Friday, April 12, 2002

In accordance with the Board's rules, the Air Line Pilots Association submits the following comments concerning the accident involving Comair Airlines Flight 5054, which occurred on March 19, 2001 near West Palm Beach, Florida.

Figure 4

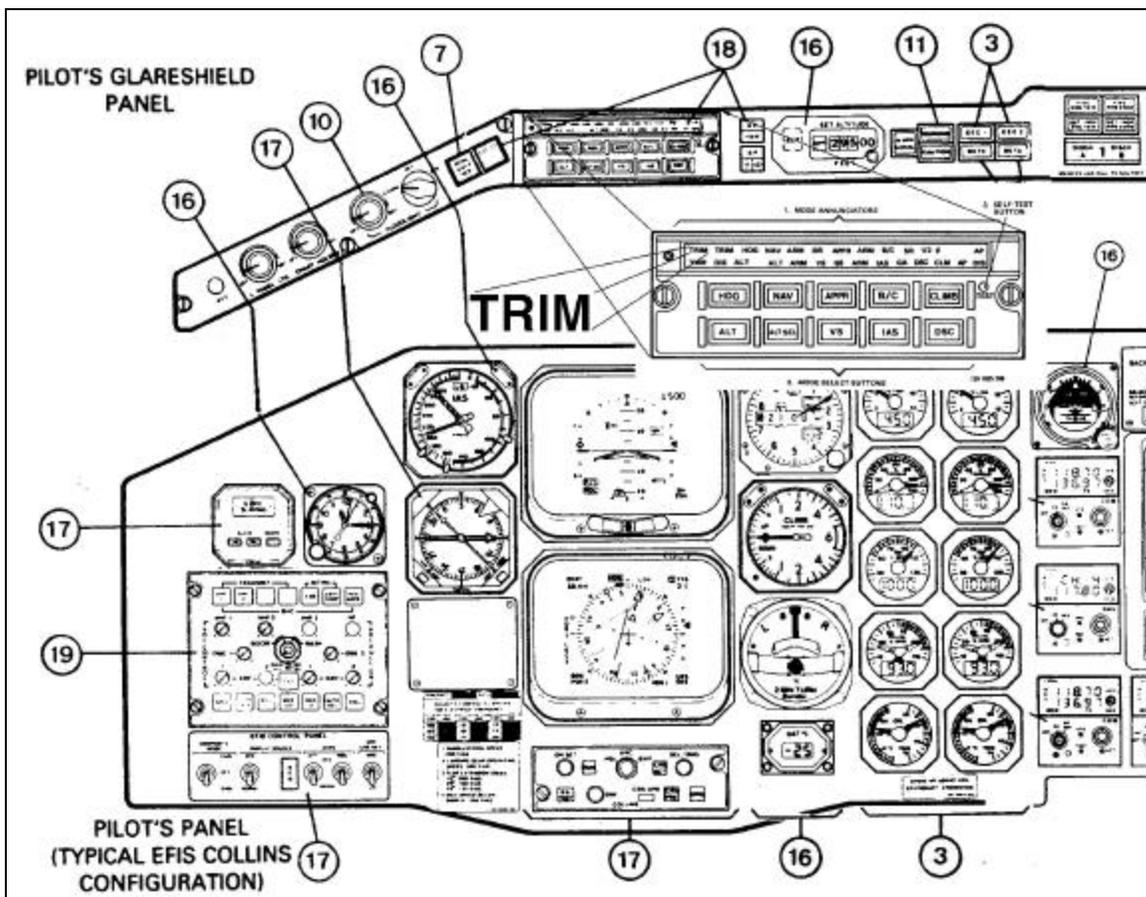
Figure 4 shows that the annunciator light provided for elevator trim in motion is not an adequate alerting indicator unless the crew already has their attention focused on this panel. The “TRIM” annunciator is in white, and illuminates to indicate that the trim system is in motion.

4. The manufacturer should develop a modification to the aircraft warning systems to make an aural alarm to indicate that the horizontal trim is in motion.

Figure 5

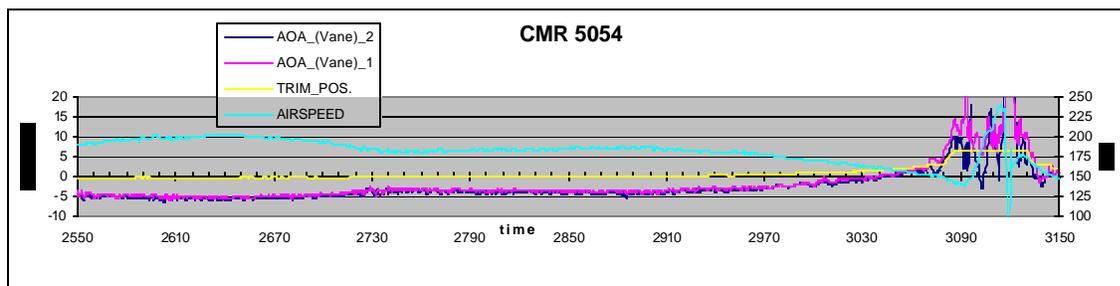
The graph in Figure 5 clearly shows that the AOA reached just 10 degrees as the trim reached a limit. Similarly, the Performance Group factual report documents the degradation in the lift coefficient to under 10% of the nominal lift coefficient (as a function of AOA), as the angle of attack (AOA) increases past 5°.

5. The manufacturer should modify the logic in the stall warning system for the EMB-120 to decrement the angle of attack at which the stall warning system activates the stick pusher so that the airplane cannot approach the stalled condition when in icing environmental conditions.

Figure 6

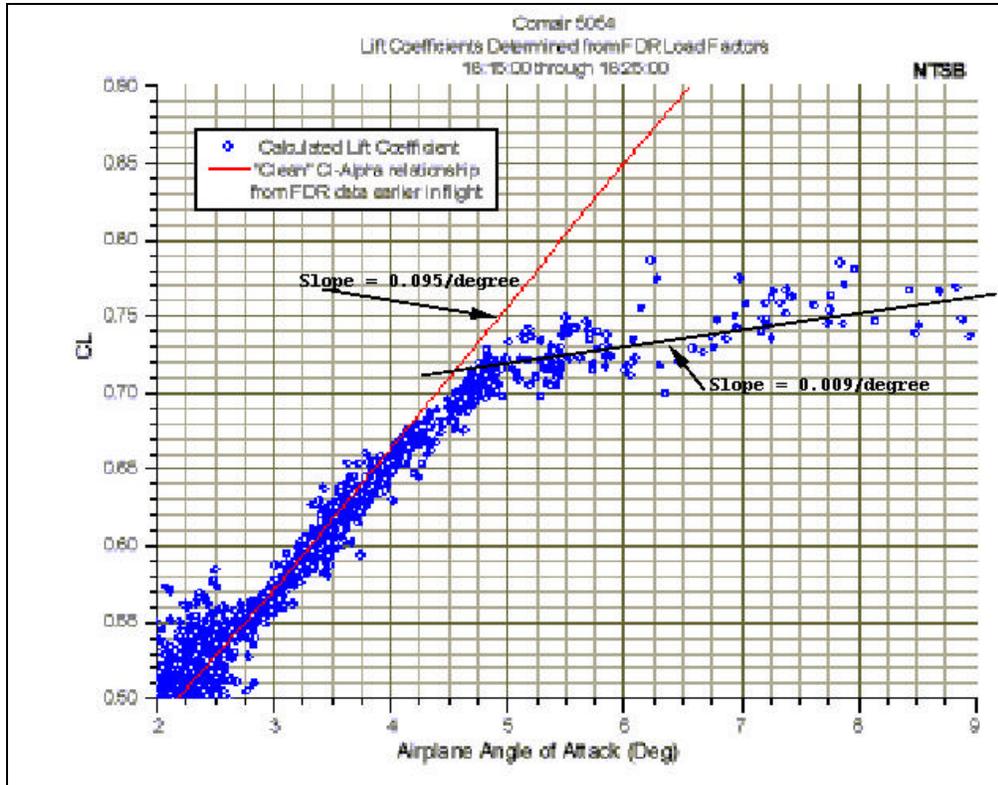
The factual report of the Performance Group contains graphs that clearly show the lift coefficient degrades with ice accretion (see figure 3 of the Performance Group Factual Report, Figure 6 below). This graph shows that the lift coefficient for the uncontaminated wing had a regular relationship increasing as the angle of attack increased, however for the contaminated wing, based on the actual flight data, the lift coefficient increased proportional to the AOA at only 9.5% of the rate of increase experienced below 5° AOA.

This degradation of the lift coefficient resulted in a significantly degraded aircraft performance. Such a characteristic resulted in the airplane rapidly losing speed as the autopilot trimmed the elevator trim tab in an attempt to achieve a higher lift coefficient in order to maintain altitude.
